APPENDIX 62

UNITIZATION PROCEDURES FOR BOXED AMMUNITION AND COMPONENTS ON 4-WAY ENTRY PALLETS

CARTRIDGE, SIGNAL, PACKED 500 PER WOODEN BOX, UNITIZED 12 BOXES PER 35" X 45½" PALLET; APPROX BOX SIZE 29" L X 12" W X 12½" H

REVISION NO. 1, DATED JULY 1984, CONSISTS OF:

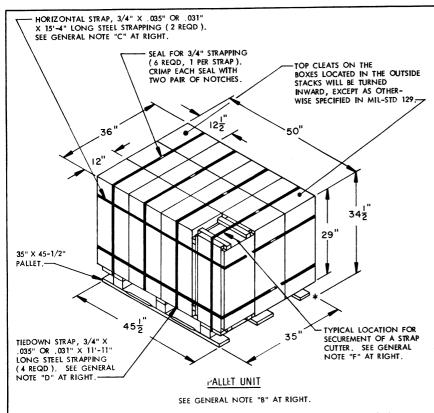
- 1. CHANGING BOX DIMENSIONS.
- 2. REORIENTING BOXES ON PALLET.
